RESPONSE TO FEMA COMMENTS ON SMITH CANAL CLOSURE DEVICE CLOMR

Subject: Interior Drainage / Street Detention Storage

Project: Smith Canal Drainage Shed

SMITH CANAL TOPO

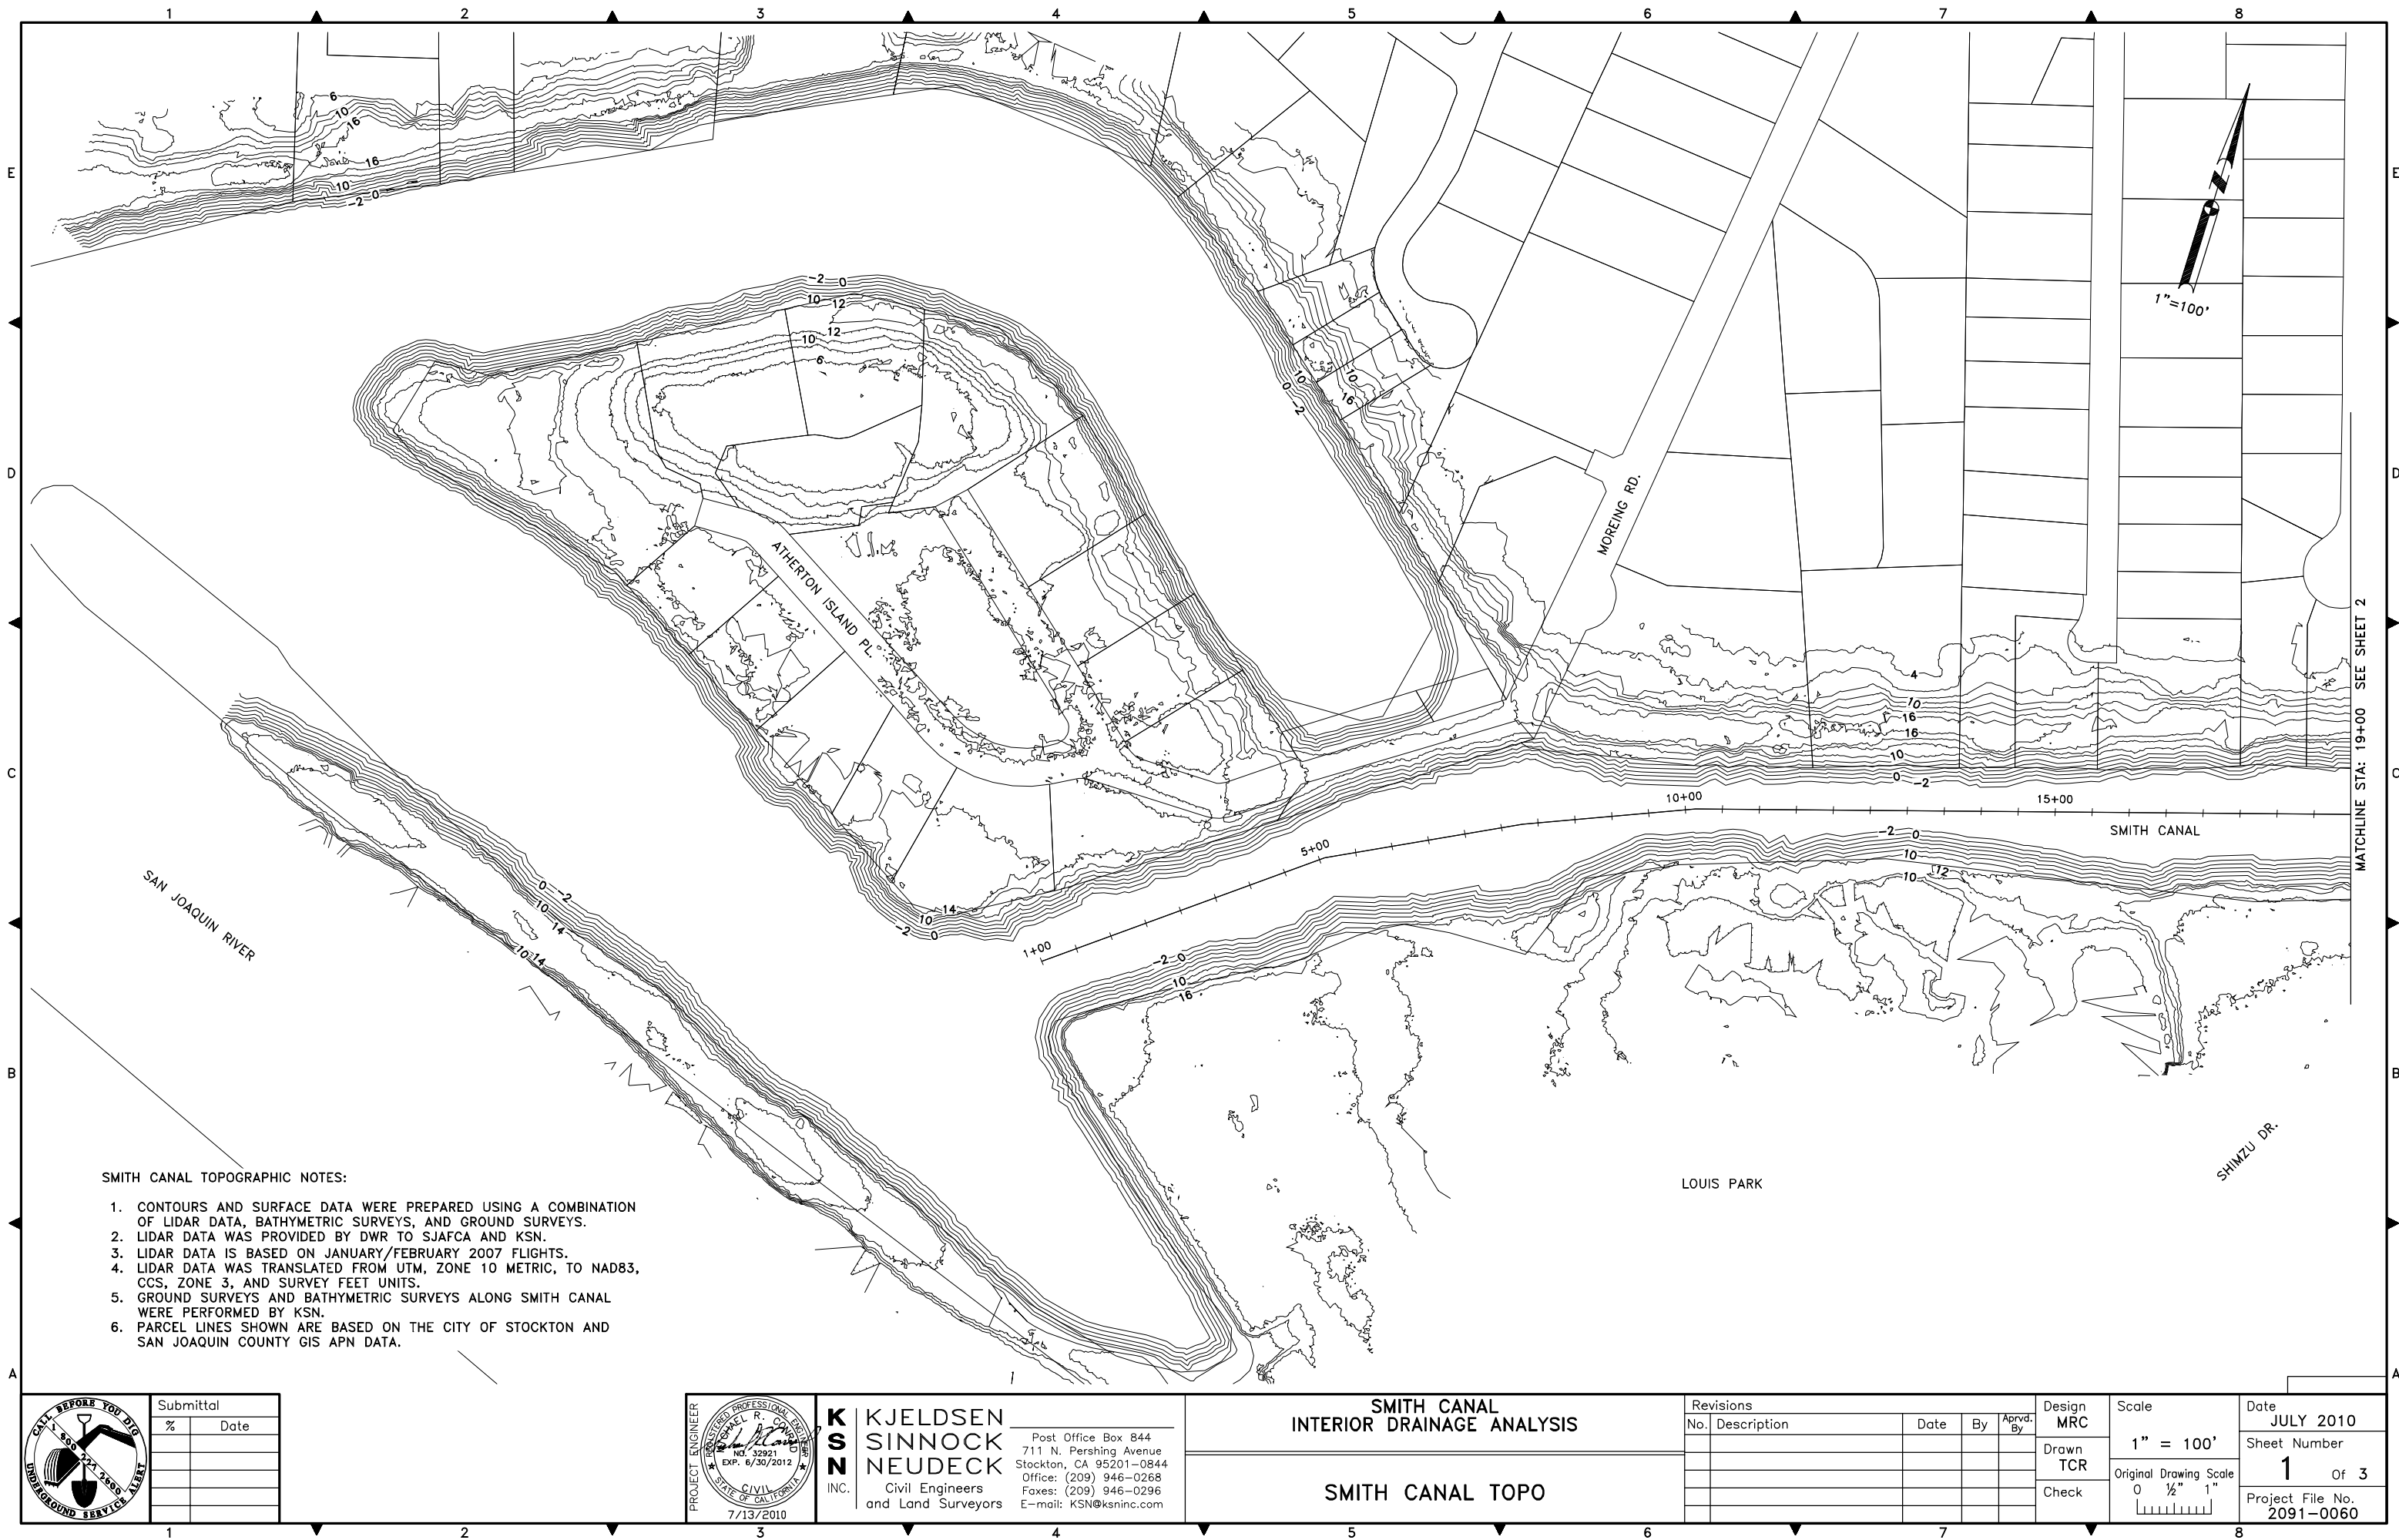
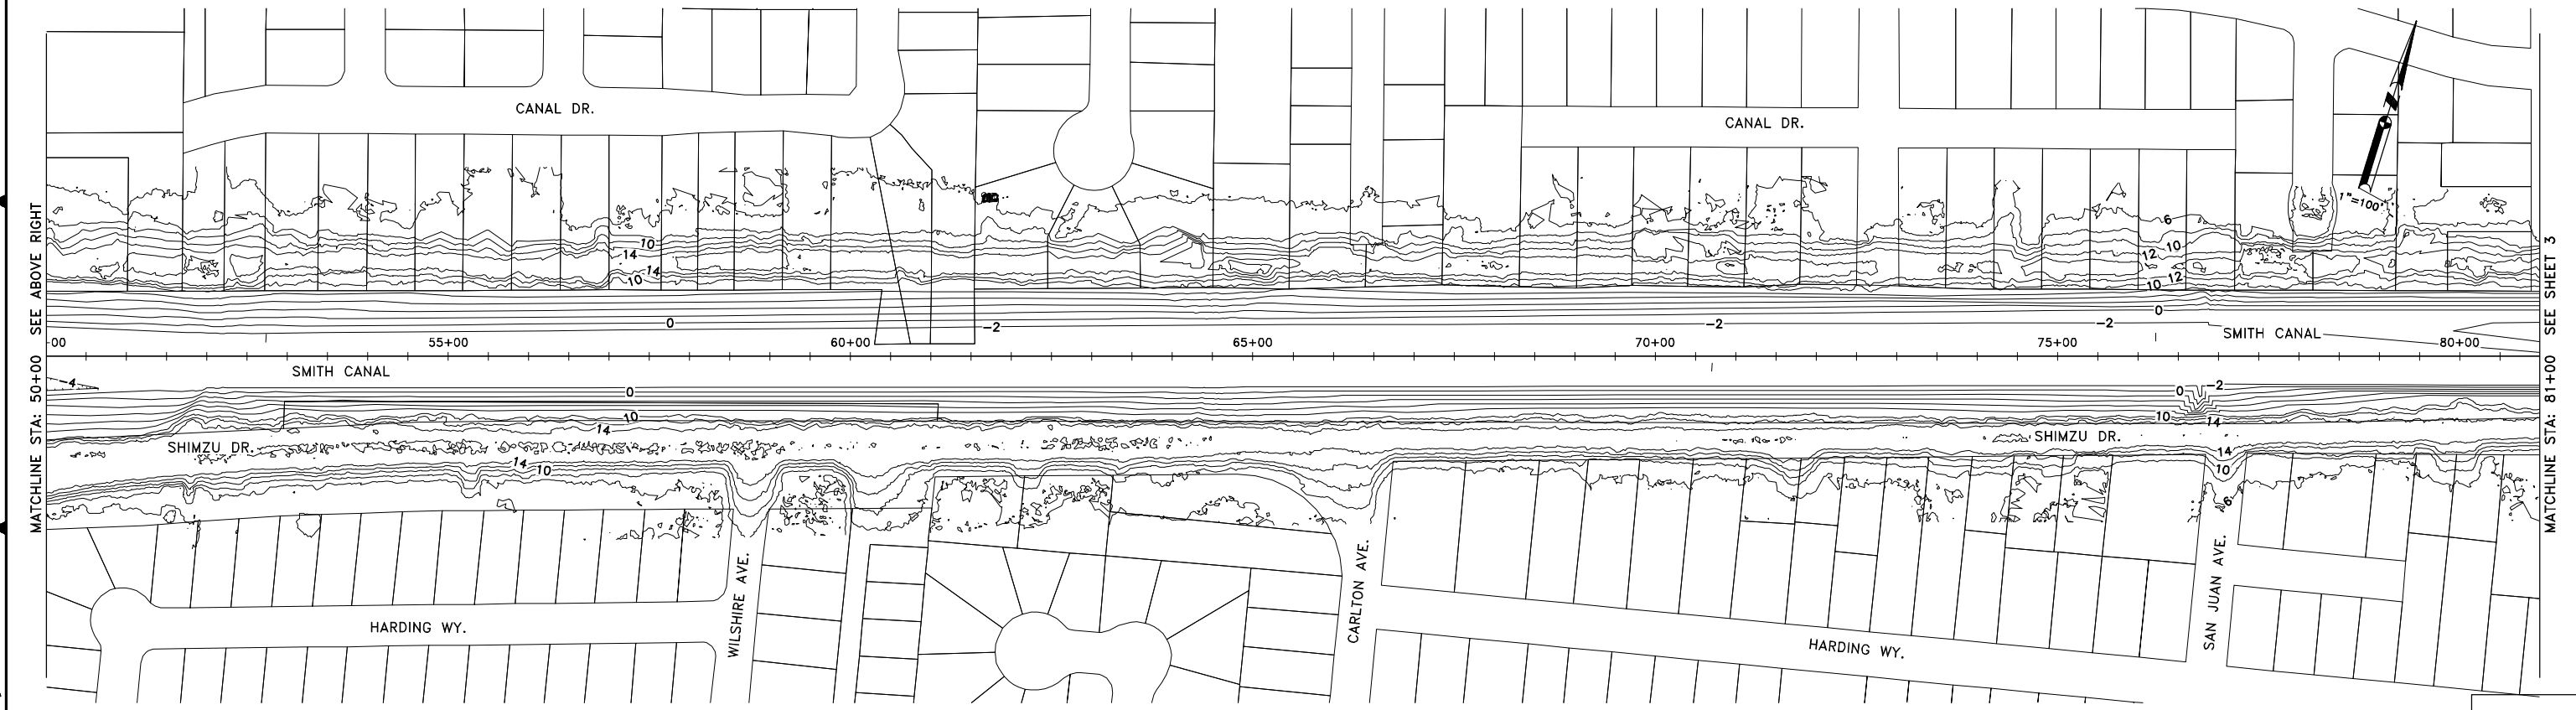
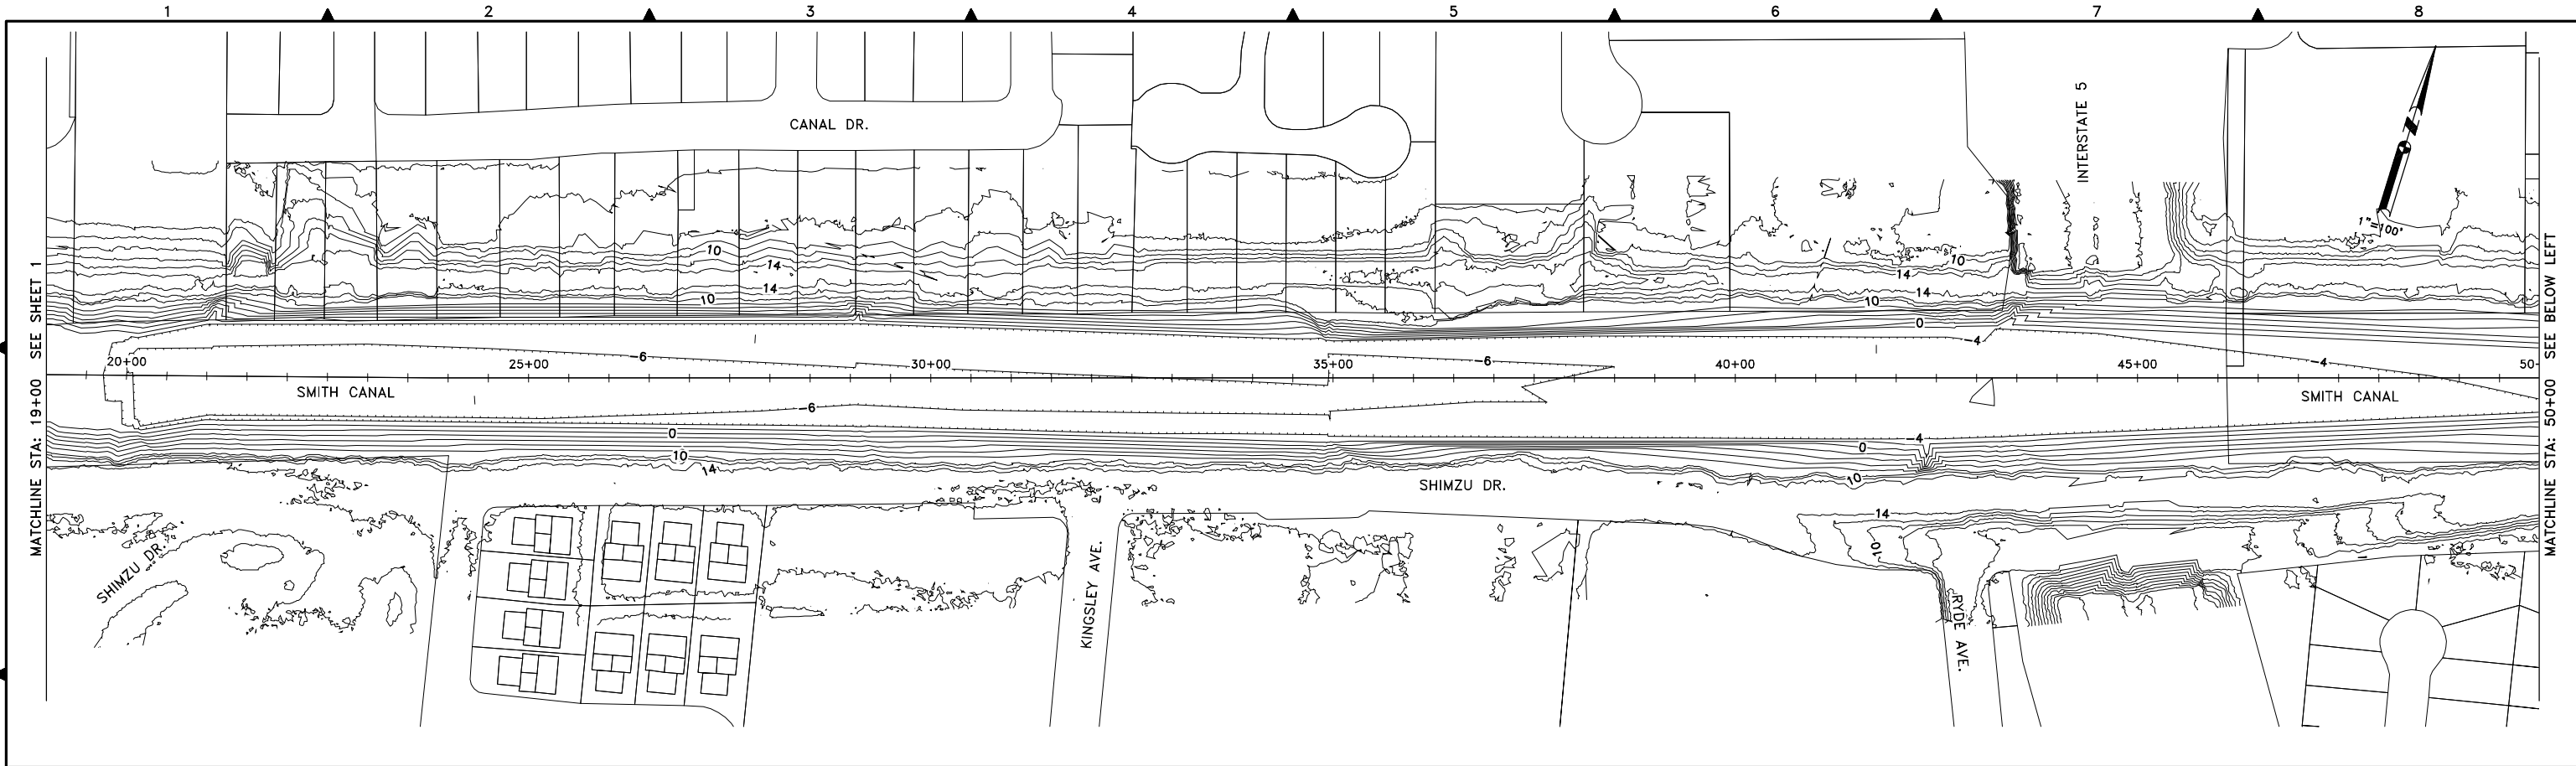
- 6) *Please provide the topographical data used for the Smith Canal storage calculation. The topo should be certified by a registered engineer.*

Response: A topographic map of Smith Canal is provided (Attachment 2).
